CALIFORNIA COASTAL COMMISSION

ADDENDUM

Subject: Addendum to **Item 17a**, Coastal Commission Permit Application **#6-22-0748 (National City, Bayshore Bikeway Segment 5)**, for the Commission Meeting of May 10, 2023

EXHIBIT NO. 8
APPLICATION NO. CDP 6-22-0748
Public Access Element
 California Coastal Commission

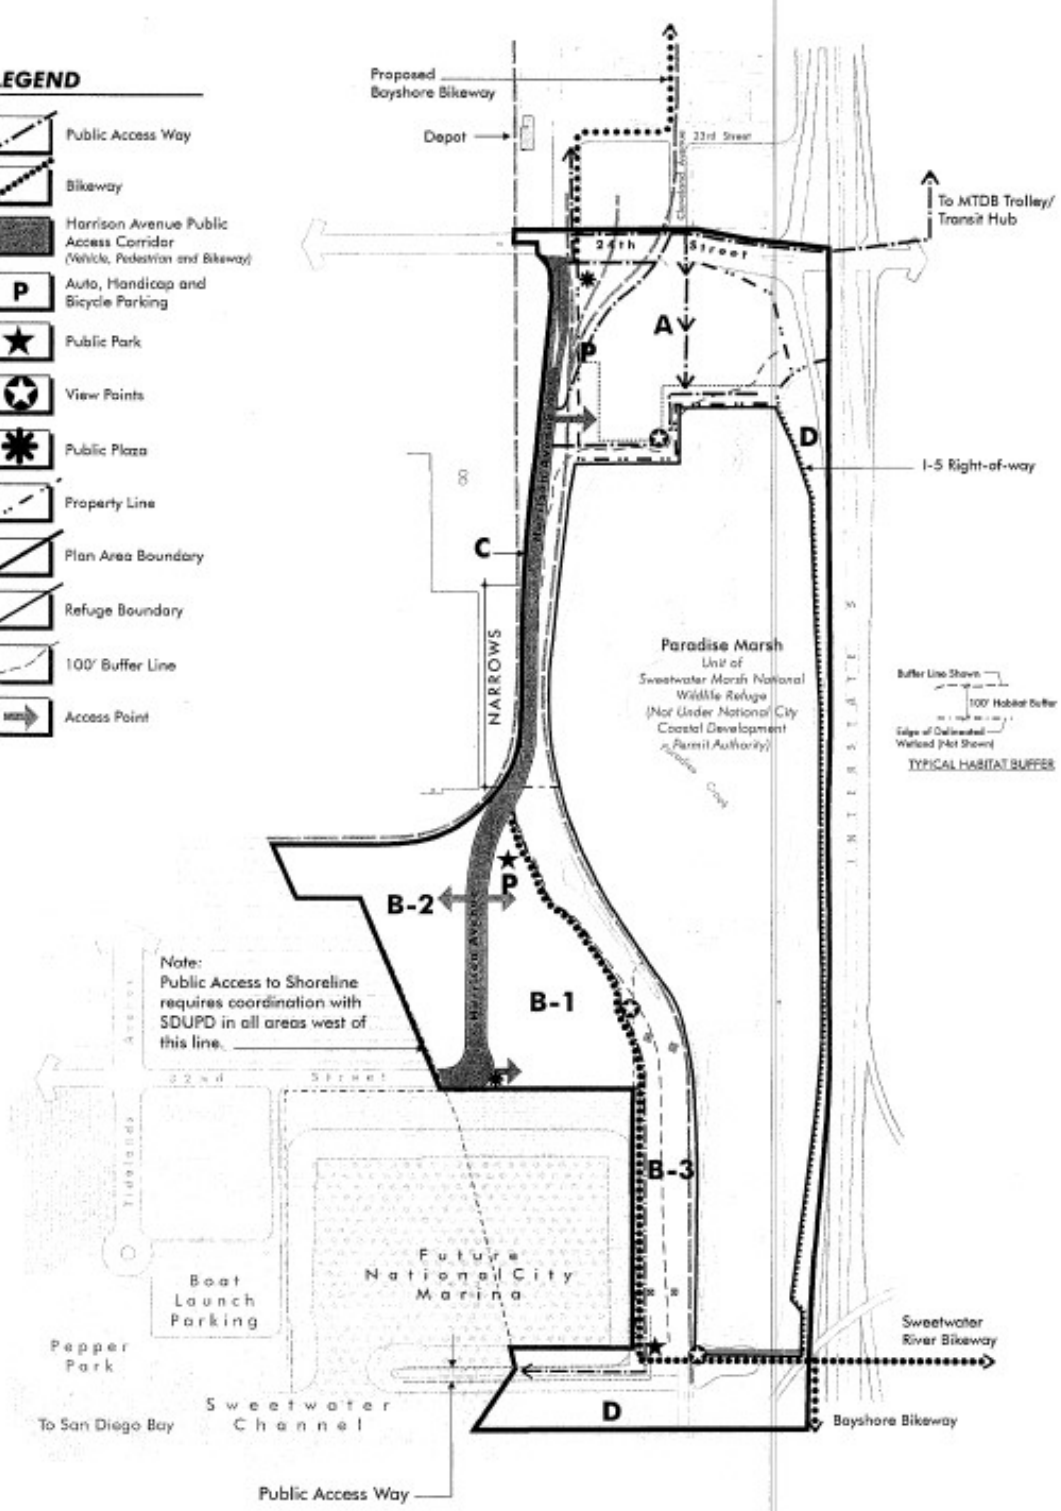
3) The commenter requests inclusion of two public parks and two viewpoints to ensure consistency with Figure 2.1 of the Harbor District Specific Area Plan, which is attached to this addendum as Exhibit 8: Public Access Element. Only one of the parks is within the project limits in parcel B-1; National City has transferred ownership of parcel B-1 to the Port of San Diego as part of the National City Balanced Plan and the Port is proposing to amend the Port Master Plan (PMP) to incorporate this parcel, construct an RV park there, and expand nearby Pepper Park in lieu of constructing the parks shown in the Public Access Element. That PMP amendment (PMP-6-PSD-23-0001-1) for the Balanced Plan is currently non-filed; however, staff notes that the proposed project would not conflict with the ultimate location of new park space, which will be considered in a future action on the Balanced Plan PMP amendment.

Regarding the two viewpoints indicated on Exhibit 8, only one is located within the project limits and the City has agreed to incorporate it into the project. Section III of this addendum revises the staff report to require the submittal of Revised Final Plans that

include a viewpoint of Paradise Marsh along the proposed alignment, to be designed in coordination with California Department of Fish and Wildlife (CDFW) and sited to avoid impacts to coastal resources.

f. Viewpoint Plan - The revised Final Plans shall include provision of a Paradise Marsh viewpoint/observation platform accessible to the general public. The viewpoint/observation platform design shall be coordinated with CDFW and designed and sited to avoid impacts to coastal resources.
